File No. 82071A

November 1, 2018

**RE: Storage Shed at the West end of the Huron Park Arena**

**Shed Wall Temporary Repairs**

**Cracked Retaining Wall – Olympia Room**

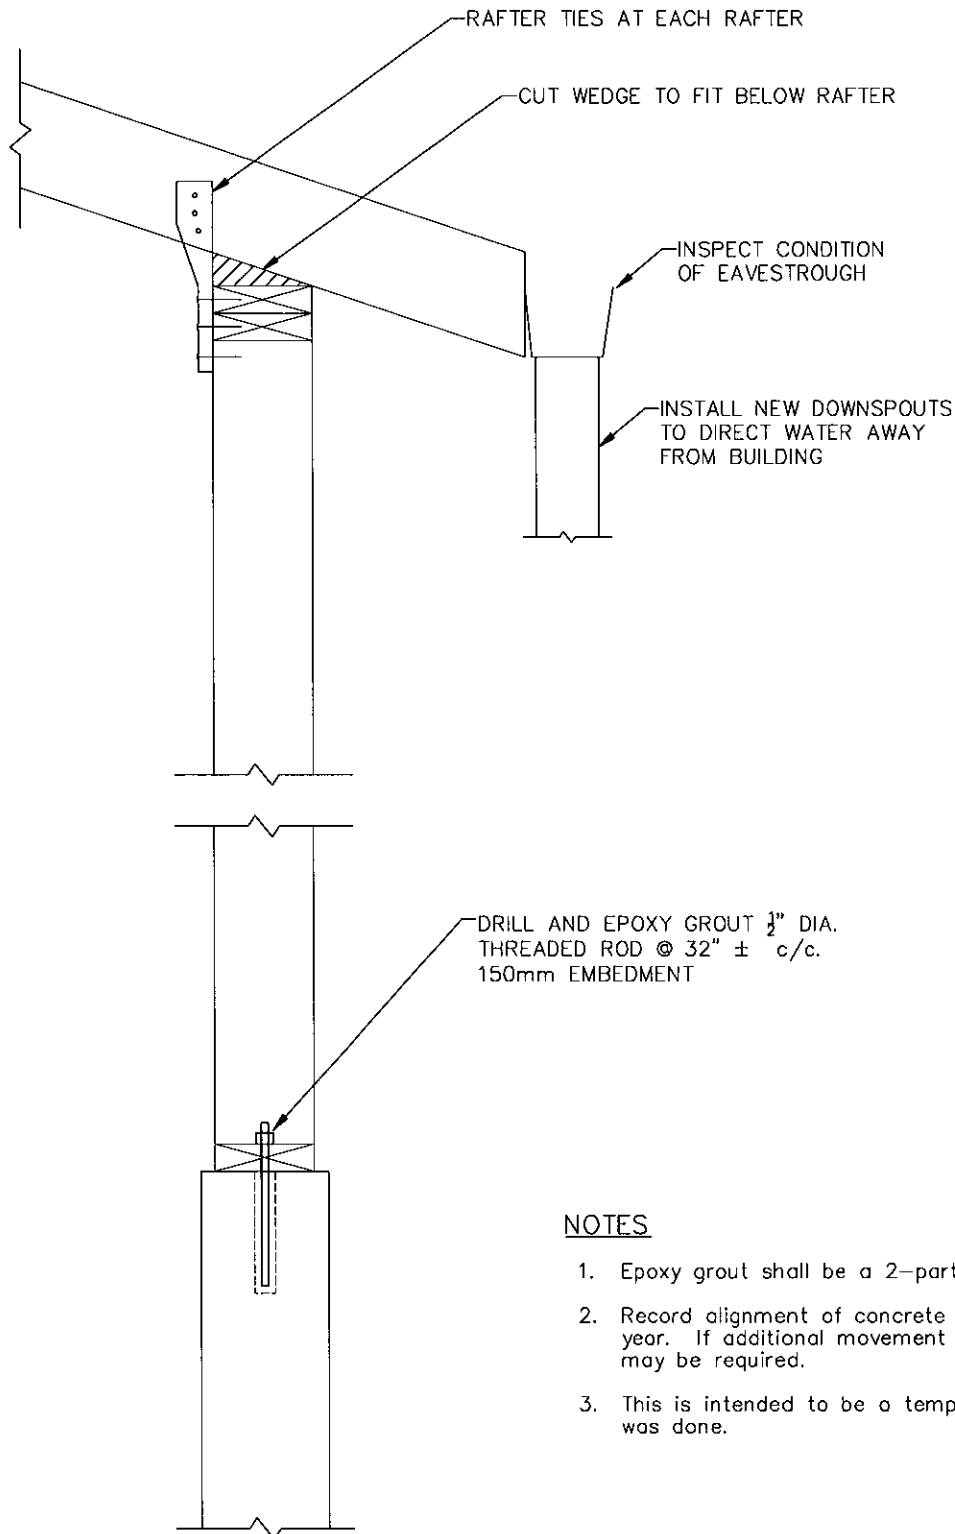
The shorter concrete retaining wall continuing past the shed is about 760 mm in height and is leaning outwards at the top by as much as 7.3% south of the shed. There is an 8 mm shear ledge in the concrete foundation wall where the tall and short retaining walls meet near the north end of the shed.

The concrete floor in the shed is badly cracked and appears to have settled about 75 mm adjacent to the west concrete foundation wall.

We recommend monitoring the movement of the west foundation wall and the stud wall at the end of each ice season to compare the amount of movement to the numbers that were recorded on the inside of the wall on the date of our review. Movement of the wall by an additional 20 mm over a length of 1220 mm would suggest that reinforcement or replacement is required prior to the next ice season.

We recommend providing a positive connection between the top of the foundation wall and the bottom of the stud wall, and between the top of the stud wall and the rafters. An example for improvements is included in Appendix 2. However, staff or a builder, may have some more practical means for improvements.
